Exception Request No.: 41
Section: WBR3
Town: Campton
Highway: US 3 (Tier 2)
Station: 2154+25±
Drawing No.: WBR3 C179
Survey Report Cross Reference No.: WBR3 C175
Exception Type: Crossing Over Existing Drainage Structure

EXCEPTION 41 - CROSSING OVER EXISTING UTILITY/DRAINAGE
NPT WBR3 - UNDERGROUND ALIGNMENT
WBR3 SECTION - STA 2154+25
SCALE: DATE: 05/2017

TITLE:
 EXCEPTION 41 - CROSSING OVER EXISTING UTILITY/DRAINAGE
 NPT-WBR3 UNDERGROUND ALIGNMENT
 WBR3 SECTION-STA 2154+25±
 TOWN: CAMPTON

UG ALIGNMENT PLAN
SCALE: 1"=30'

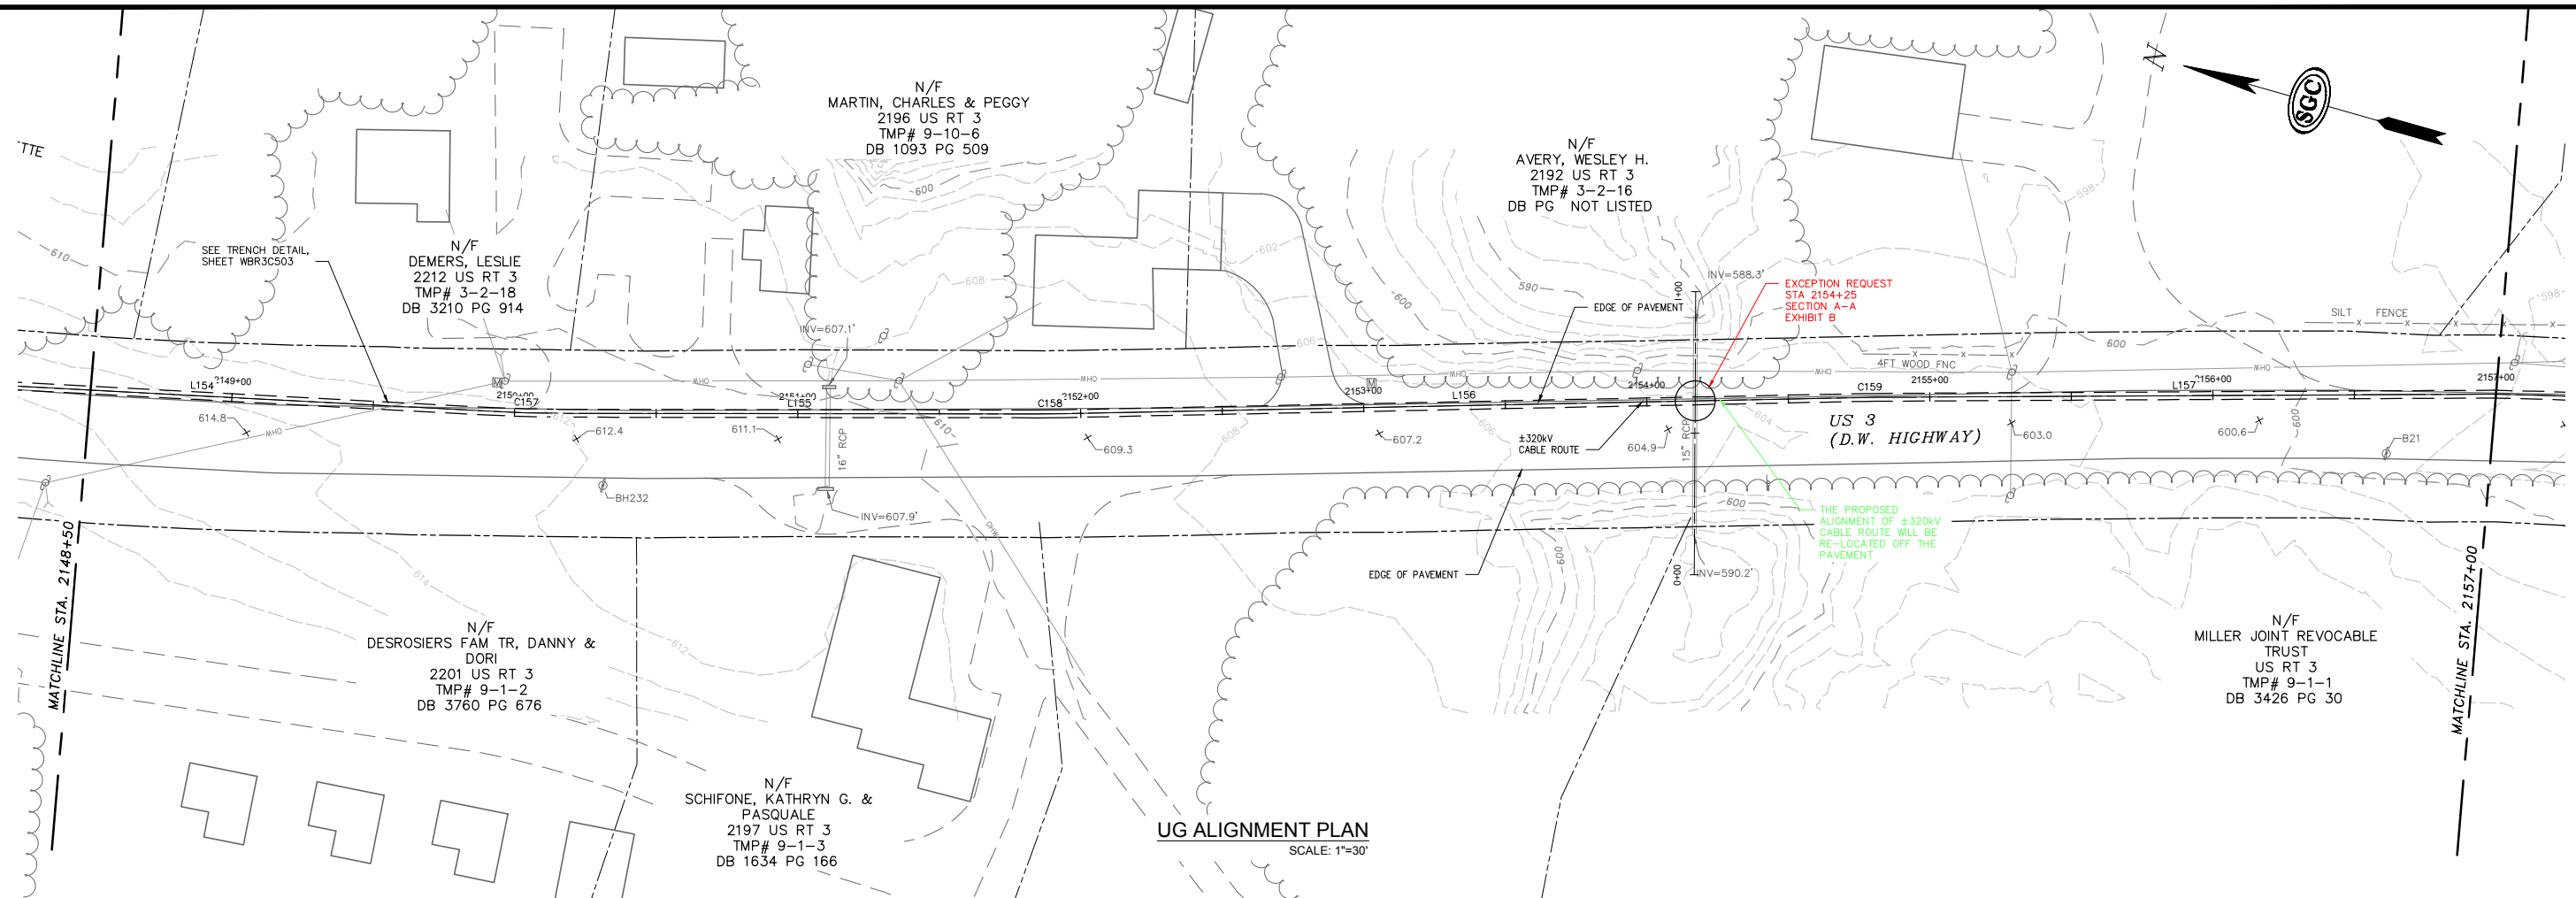
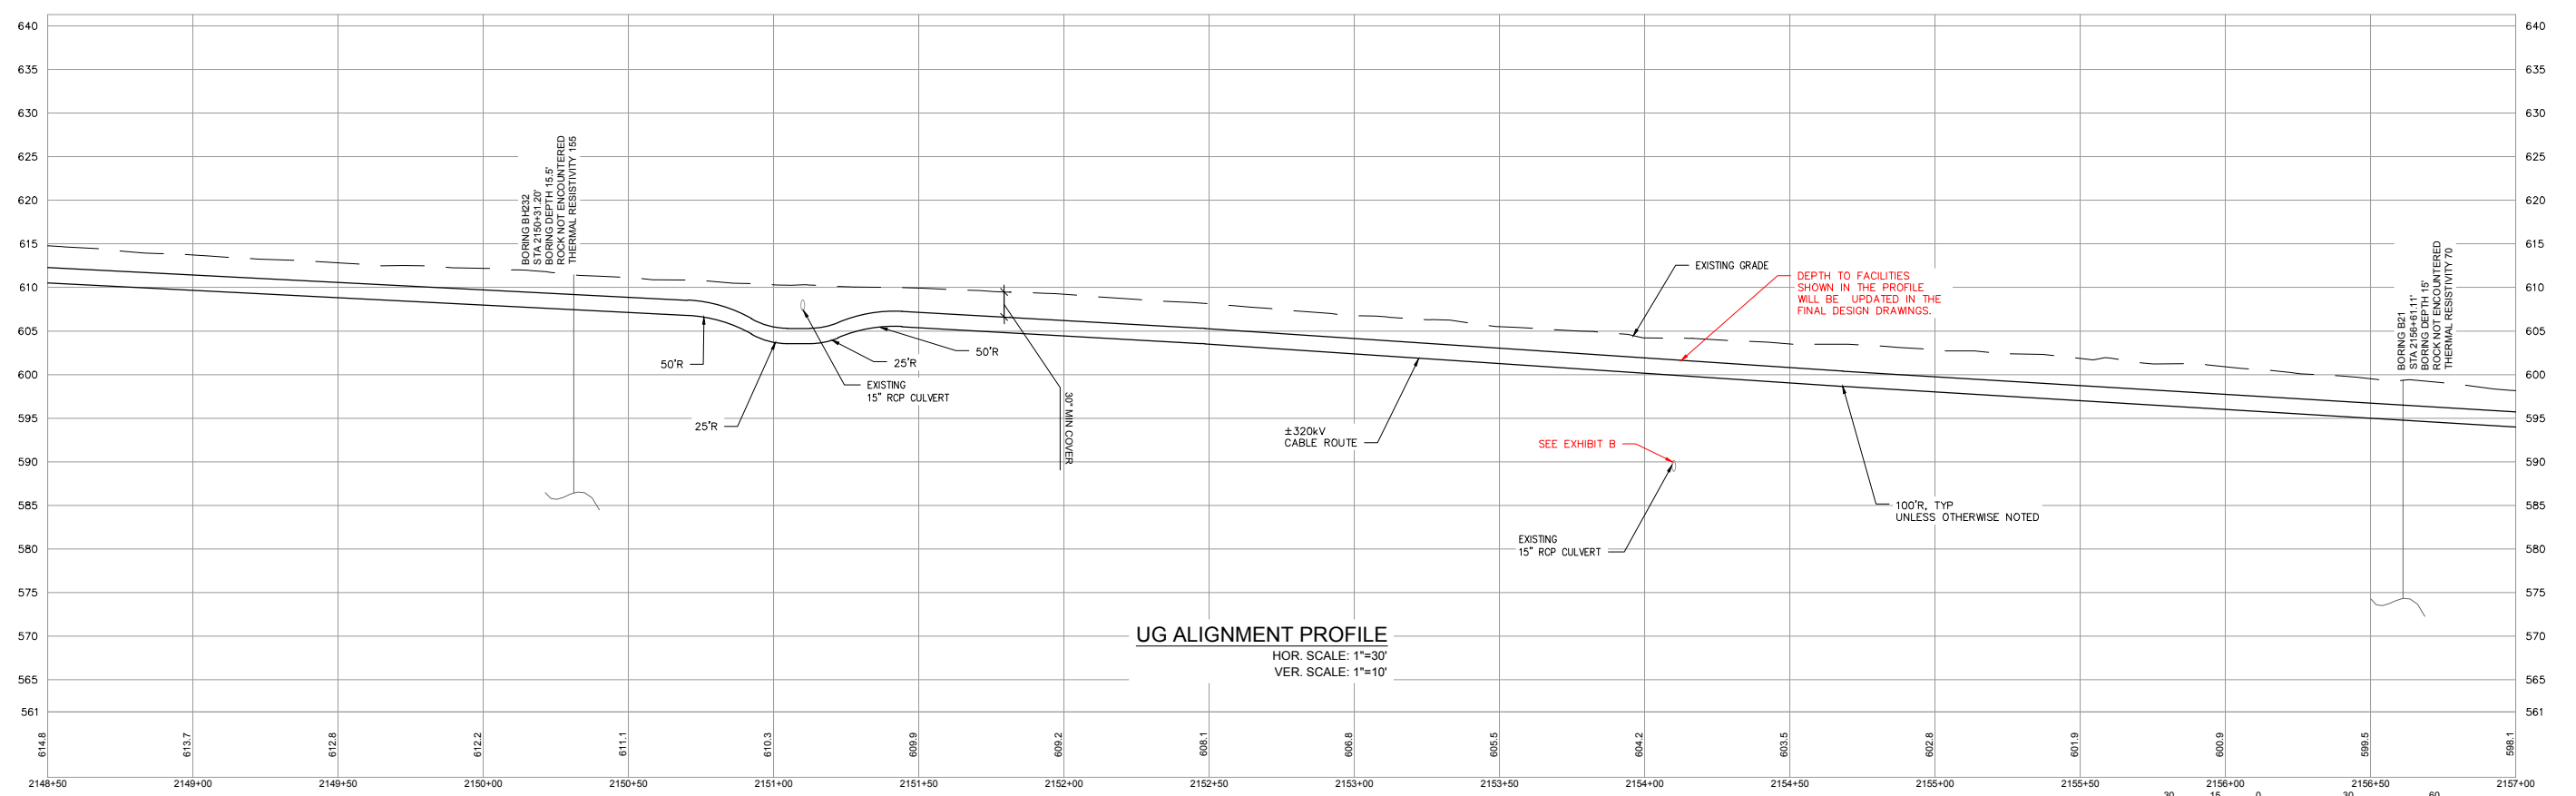
The vertical positioning of the cable trench is constrained by the depth of the existing culvert (thirteen feet to the top of the culvert). (See Exhibits A and B). Crossing under the existing culvert to meet the required 2-foot minimum separation will require a greater separation of the conduits and cable to accommodate shoring and thermal design criteria for the electric cables resulting from the additional depth. This trench width and additional offsets necessary for construction would likely result in significant traffic impacts, including extended duration of construction within roadway to allow for sheeting installation and removal and extensive excavation due to the depth and width of the trench. We estimate that these construction alternatives will add one to two weeks to the traffic impacts. Finally, we estimate the increase in cost associated with crossing underneath the culvert would be approximately \$200,000 for this 200-foot section. (See Exhibit C.) Road closures are not needed for the proposed installation, which thereby minimizes traffic impacts and attendant safety issues.

Note: On Exhibit A, the alignment of the ductbank in the area of this exception is shown in the roadway. NPT intends to move the alignment out of the roadway in this area, which will be reflected in the final plan drawings.

SECTION A-A

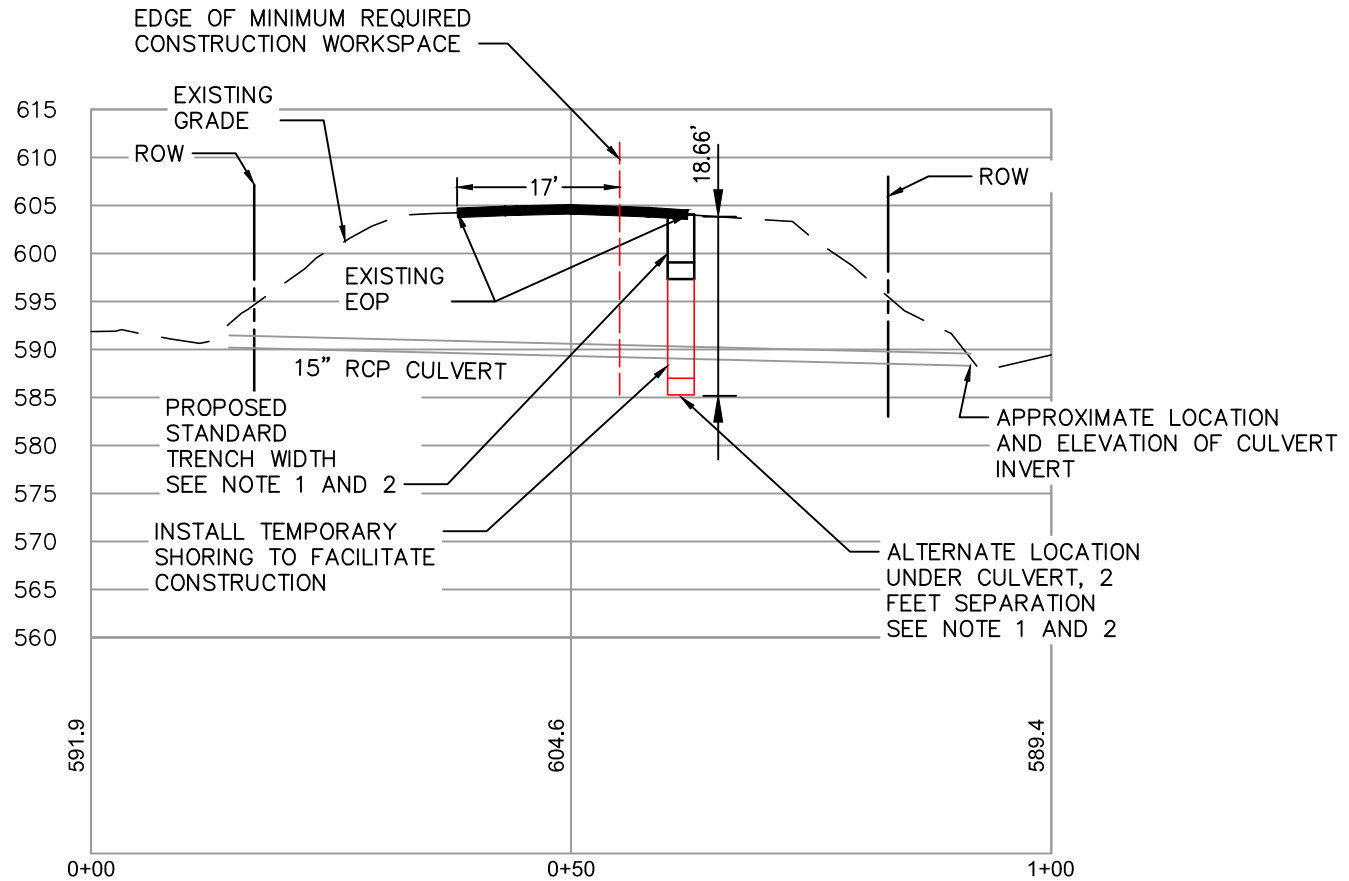
1. TRENCH WIDTH SHOWN TO BE MAINTAINED USING TRENCH JACKS AND SHEETING
2. PROPOSED CABLE ROUTE TO BE MOVED OUTSIDE PAVEMENT LIMITS. CHANGE IN ALIGNMENT WILL PROVIDE ADDITIONAL ROOM FOR WORKSPACE AND MAINTENANCE OF TRAFFIC.
